TRAFFIC SAFETY COMMITTEE

SUBJECT: INTERSECTION OF HASTINGS AND INLET

SUBJECT: INTERSECTION OF HASTINGS AND INLET

Exhibit 1

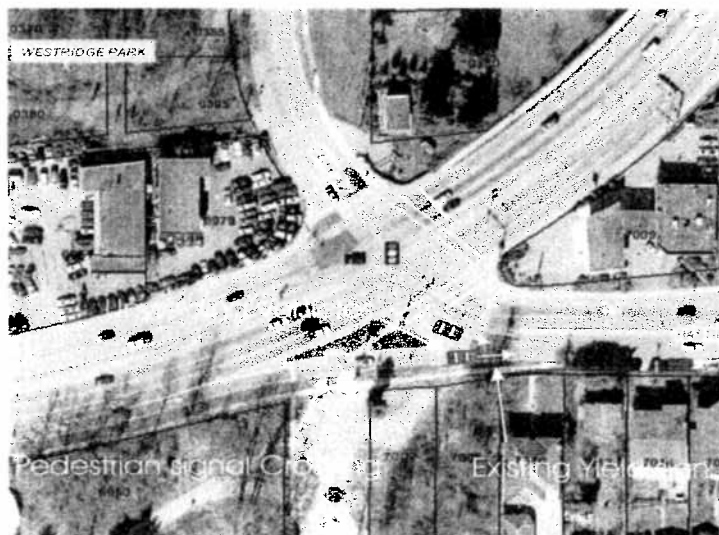
At the March 6, 2007 Traffic Safety Committee Meeting we received correspondence from Ms. Kimberly Cairns of 7376 Halifax Street regarding the safety of vehicles proceeding east on Hastings Street at Inlet Drive (see exhibit 1).

Ms. Cairns states that at this intersection, vehicles using the right turn sweep from Hastings onto Hastings routinely violate the yield sign at excessive speed causing her near collisions on several occasions. She suggests RCMP enforcement and replacing the yield with a stop sign.

This intersection comprises two Arterial Primary (Hastings/Inlet) and a Local Collector (Cliff). The intersection possesses two signal systems, one for the major intersection and a separate pedestrian signal on the Hastings to Hastings sweep. The sweep has a large radius curve that is conducive to maintaining the travel speed when exiting. In addition, sight lines are good further raising the confidence drivers approaching the yield.

Replacing the yield with a stop is not warranted because the sightlines provide adequate warning of approaching vehicles and merge symmetry is present. Compliance for a stop sign here would likely be low and may even cause a rise in rear end collisions.

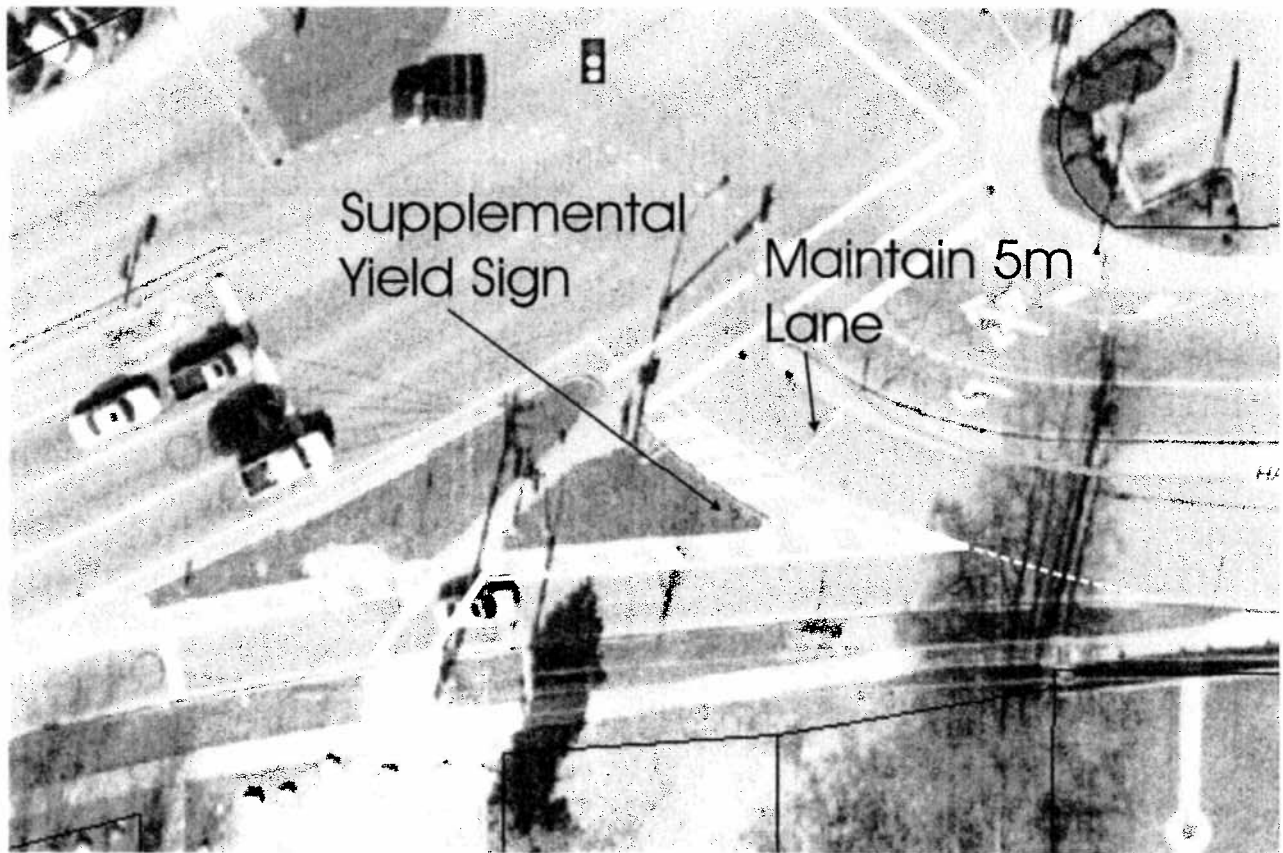
In order to mitigate right of way conflicts, slow down traffic and better define the yield requirements, the following adjustments are to be completed (see exhibit 2)

1. Add gore markings to the painted edge line on the sweep and repaint the crosswalk. This will give a perceived narrowing effect and reinforce the presence of the crosswalk in an attempt to slow traffic.
2. Add gore markings and reduce the lane width from the Cliff/Inlet access to Hastings creating more separation between the through and merge lanes.
3. Add wide broken line across merge lane onto Hastings to better define right of way.
4. Add a supplemental yield sign on the left hand side of the sweep at Hastings to reinforce right of way.
